Add canopies over 34 existing parking spaces and eliminate one parking space to provide secured bicycle storage.

Case Numbers	Action	Fees
SI-2020-01163	AA	
-		
-		
Meeting/Hearing Date:		Fee Total:
Staff Signature:	Date:	Project # PR-2020-004594

Re: Minor Amendment for the Huning Castle Apartments

From: [Michael Vos](#)
To: [Wolfenbarger, Jeanne](#)
Cc: [Jim Strozier](#); [Armijo, Ernest M.](#)
Subject: RE: 1500 Central Avenue AA
Date: Tuesday, January 19, 2021 3:08:47 PM
Attachments: [image001.jpg](#)
[Huning Castle Apartments Amended Site Plan-compressed.pdf](#)

8 COVERED PARKING SECT.

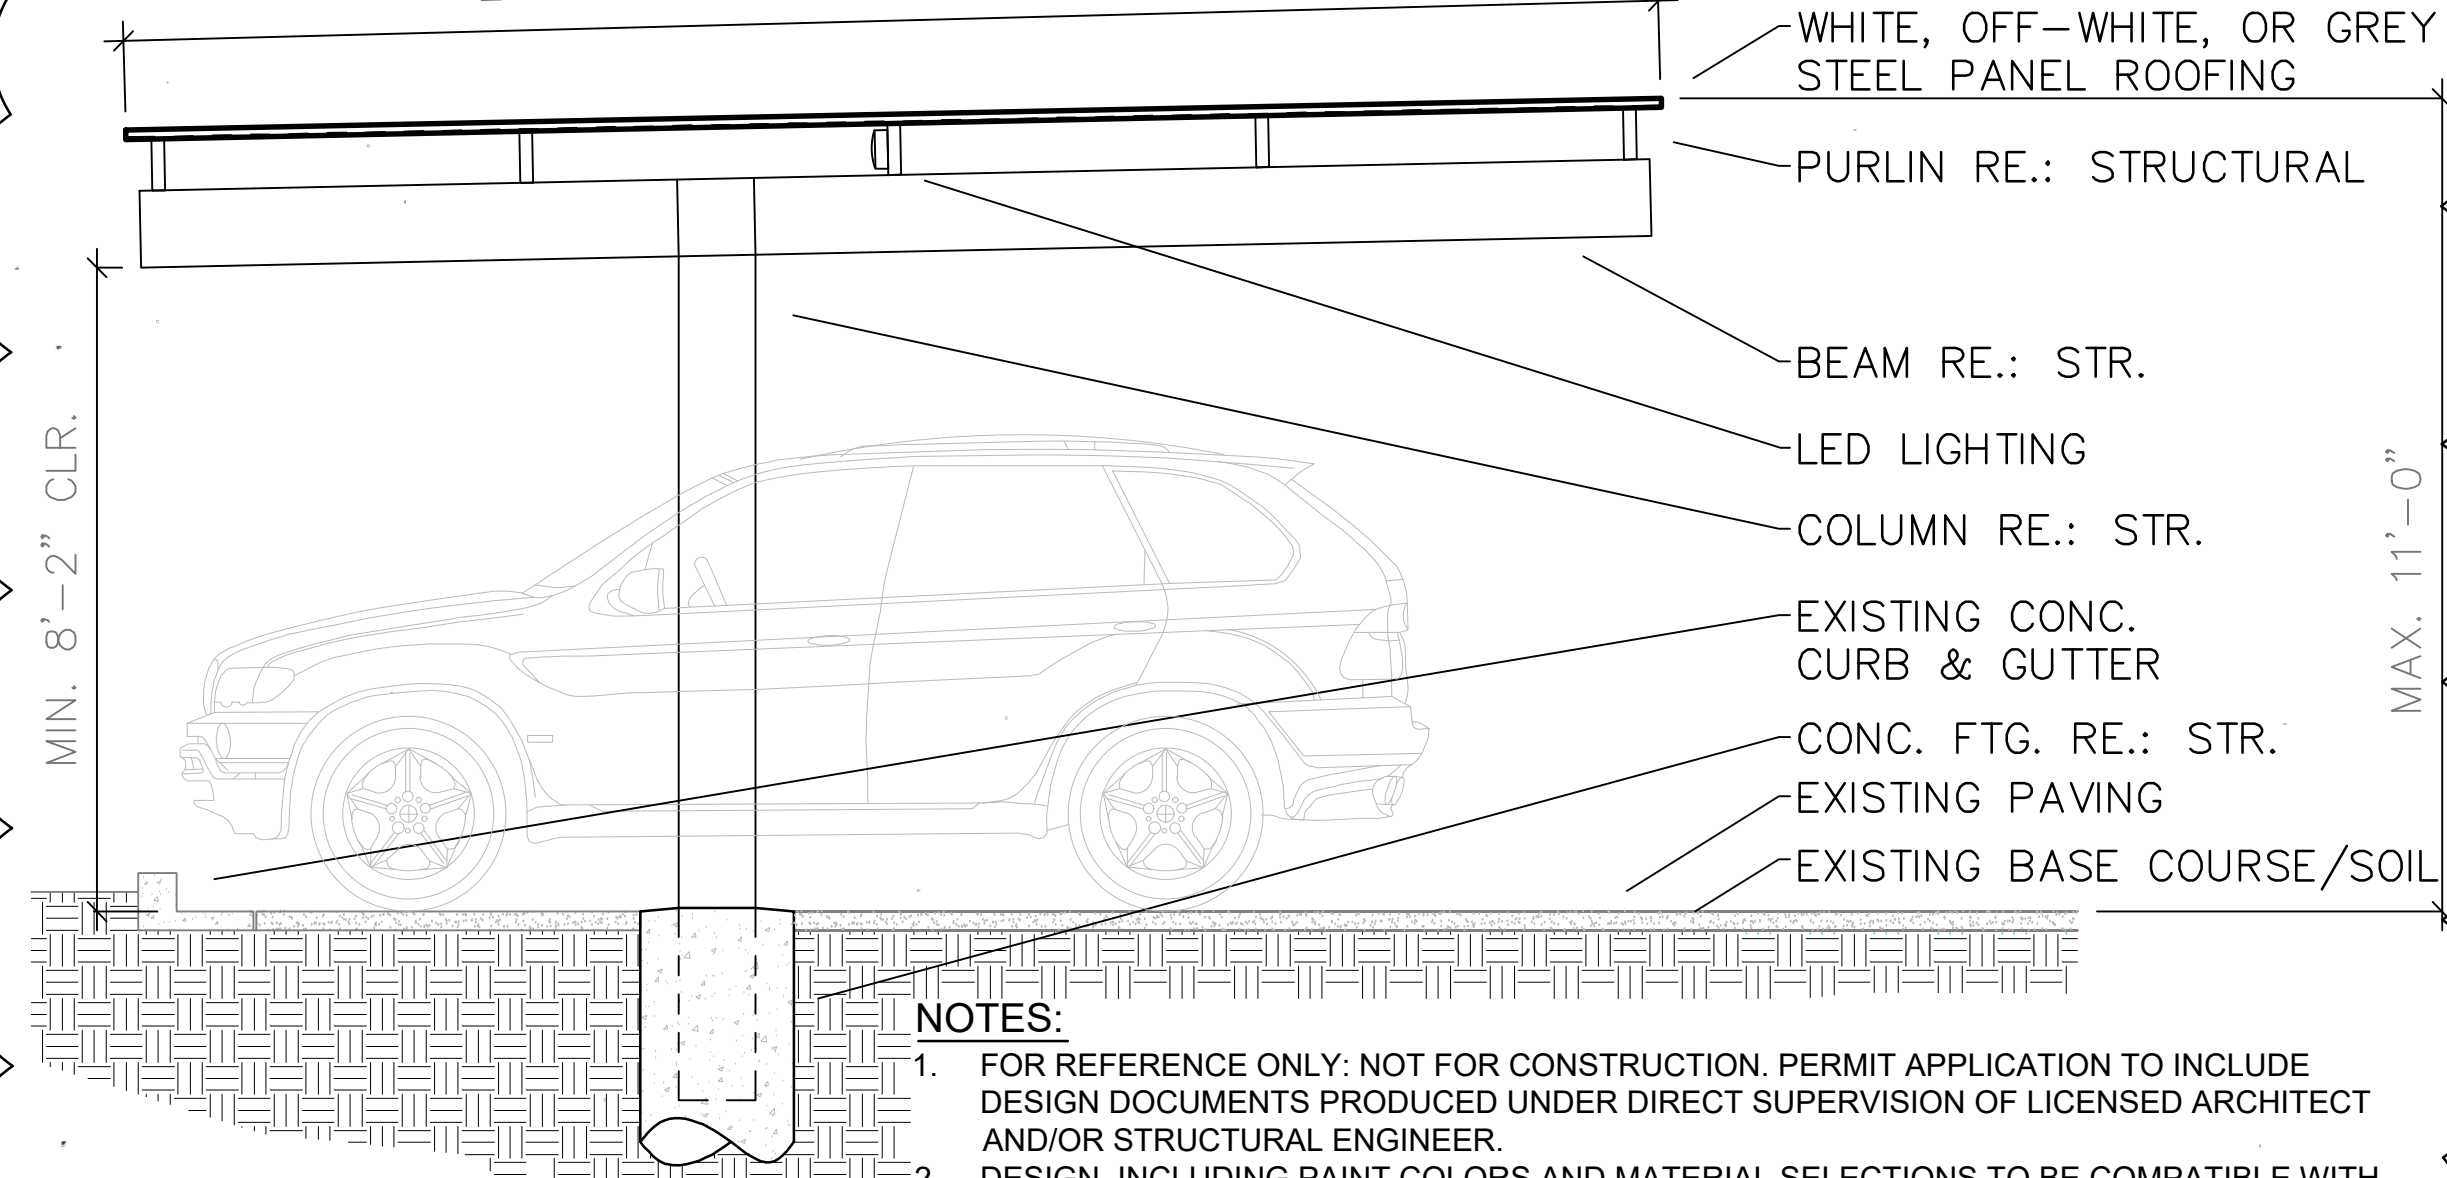
- Add canopies along the western section of existing parking spaces covering 34 of the original 119 parking spaces. The area of sheltered parking is identified on the revised site plan (Sheet A001) and an elevation detail is added to the site details and exhibits (Sheet A008).
- Eliminate one parking space at the southernmost end of the sheltered parking in order to convert it to secured bicycle storage.

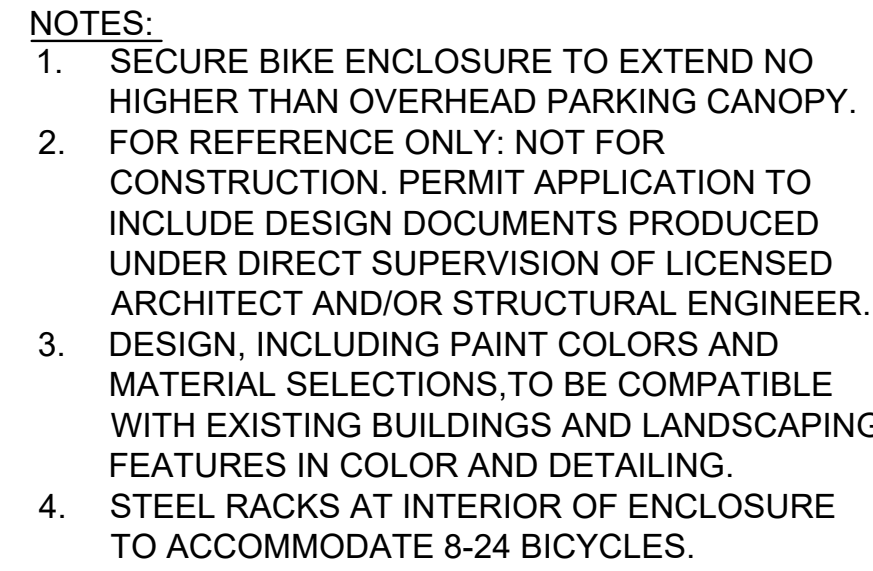
Hello again, Jim. I am just checking in with you regarding the subject AA. I never saw a response and just had the one comment.....

Jim, I had been reviewing the AA for this, and the only comment I had was that I could not find the "Bicycle enclosure" detail. Did I miss it somewhere?

It's been awhile for this project, but we had to get concurrence from Hydrology on moving this Administrative Amendment along. The revised plan is attached in case I didn't send previously, which hopefully addresses your comments with the details on the second sheet with added dimensions. This site plan, an uncompressed version, and the Hydrology approval can also be downloaded here: <https://www.dropbox.com/t/41lvnVkXZxReFv2P>

proposed AA that was submitted. The Applicant does not have a design completed at this time. However, we are working with the Client to provide a general detail to describe the size and potential materials that may be further defined at a later stage as long as it is consistent with the general detail. Does this approach sound acceptable to you?

The purpose is additional secure bicycle storage beyond the required spaces, which already exist in racks on the site. We will share the updated sheets once we have them ready.
